Access Compliance Report

Public Rights-of-Way

Intersection ID: 29229	Main Street: KORNIV_DR	Cross Street: LAUREN_KAY_CT	Location: SW
ADA ID: 529C22EF9BFE	Ramp Type: PerpDiag	Initial Pass/Fail: Fail	Overall Compliance: No
			Severity Score: 13.75

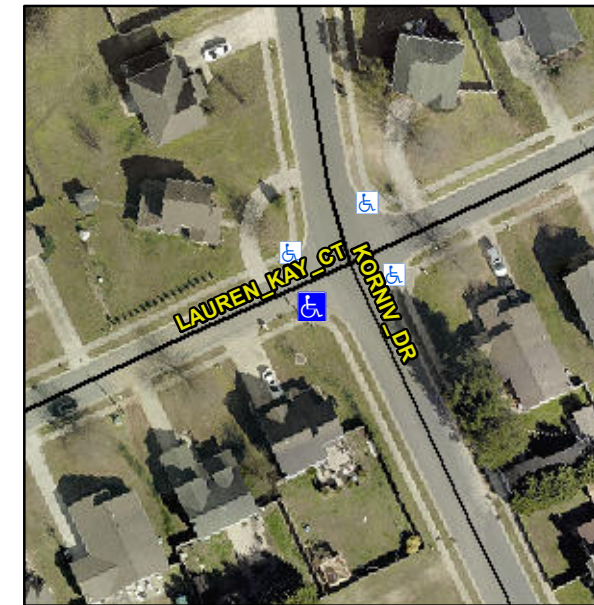
Not Found, R304.2.2, R304.5.3

Compliance	Description	Data	Compliance	Description	Data
N/A	Ramp Length (in)	54.0	No	Ramp Slope (%)	10.5
Yes	Ramp Width (in)	54.0	No	Ramp XSlope (%)	4.2
N/A	Flare Type LT	N/A	N/A	Flare Type RT	N/A
N/A	Flare Slope LT (%)	N/A	N/A	Flare Slope RT (%)	N/A
N/A	Flare Traversable LT?	N/A	N/A	Flare Traversable RT?	N/A
N/A	Landing Length (in)	N/A	N/A	DWS Provided?	N/A
N/A	Landing Width (in)	N/A	N/A	DWS Contrast?	N/A
N/A	Landing Slope (%)	N/A	N/A	DWS Length (in)	N/A
N/A	Landing X Slope (%)	N/A	N/A	DWS Full Width?	N/A
N/A	Landing Curb? (Y/N)	N/A	N/A	DWS Offset (in)	N/A
N/A	Shared Landing?	N/A			
N/A	Gutter Ponding?	N/A	N/A	Gutter Slope (%)	N/A
N/A	Gutter Lip Ht (in)	N/A	N/A	Gutter X Slope (%)	N/A
N/A	Painted X Walk1?	No	N/A	Painted X Walk2?	No
	X Walk 1 Direction	To E		X Walk 2 Direction	To N
N/A	X Walk 1 Width (in)	N/A	N/A	X Walk 2 Width (in)	N/A
	X Walk 1 Slope (%)	6.4		X Walk 2 Slope (%)	0.3
	X Walk 1 X Slope (%)	0.9		X Walk 2 X Slope (%)	3.6

Remove & Replace Curb Ramp With Two New Directional Ramps or Equivalent.
